Access Compliance Report

Public Rights-of-Way

(Curb Ramps)

Intersection ID: 46813	Main Street: ARBOR_VISTA_DR	Cross Street: OLDE_IVY_WY	Location: NE
ADA ID: 3DC51DEDF416	Ramp Type: PerpDiag	Initial Pass/Fail: Fail	Overall Compliance: No
Severity Score: 8.75			
Codes/Mitigation Info/Possible Solution		Field Measurements/Component Compliance

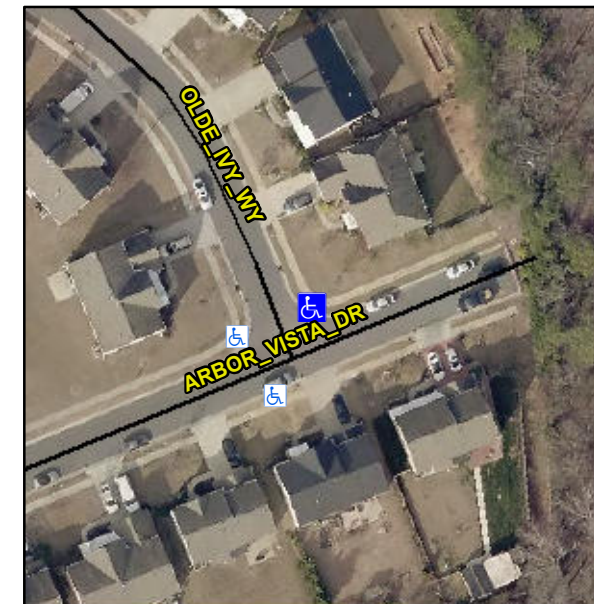
Not Found, R304.5.1

Compliance	Description	Data	Compliance	Description	Data
N/A	Ramp Length (in)	47.5	Yes	Ramp Slope (%)	5.9
No	Ramp Width (in)	39.5	Yes	Ramp XSlope (%)	0.1
N/A	Flare Type LT	N/A	N/A	Flare Type RT	N/A
N/A	Flare Slope LT (%)	N/A	N/A	Flare Slope RT (%)	N/A
N/A	Flare Traversable LT?	N/A	N/A	Flare Traversable RT?	N/A
N/A	Landing Length (in)	N/A	N/A	DWS Provided?	N/A
N/A	Landing Width (in)	N/A	N/A	DWS Contrast?	N/A
N/A	Landing Slope (%)	N/A	N/A	DWS Length (in)	N/A
N/A	Landing X Slope (%)	N/A	N/A	DWS Full Width?	N/A
N/A	Landing Curb? (Y/N)	N/A	N/A	DWS Offset (in)	N/A
N/A	Shared Landing?	N/A			
N/A	Gutter Ponding?	N/A	N/A	Gutter Slope (%)	N/A
N/A	Gutter Lip Ht (in)	N/A	N/A	Gutter X Slope (%)	N/A
N/A	Painted X Walk1?	No	N/A	Painted X Walk2?	No
	X Walk 1 Direction	To W		X Walk 2 Direction	To S
N/A	X Walk 1 Width (in)	N/A	N/A	X Walk 2 Width (in)	N/A
	X Walk 1 Slope (%)	1.0		X Walk 2 Slope (%)	0.4
	X Walk 1 X Slope (%)	1.1		X Walk 2 X Slope (%)	0.1

Remove & Replace Curb Ramp With Two New Directional Ramps or Equivalent.
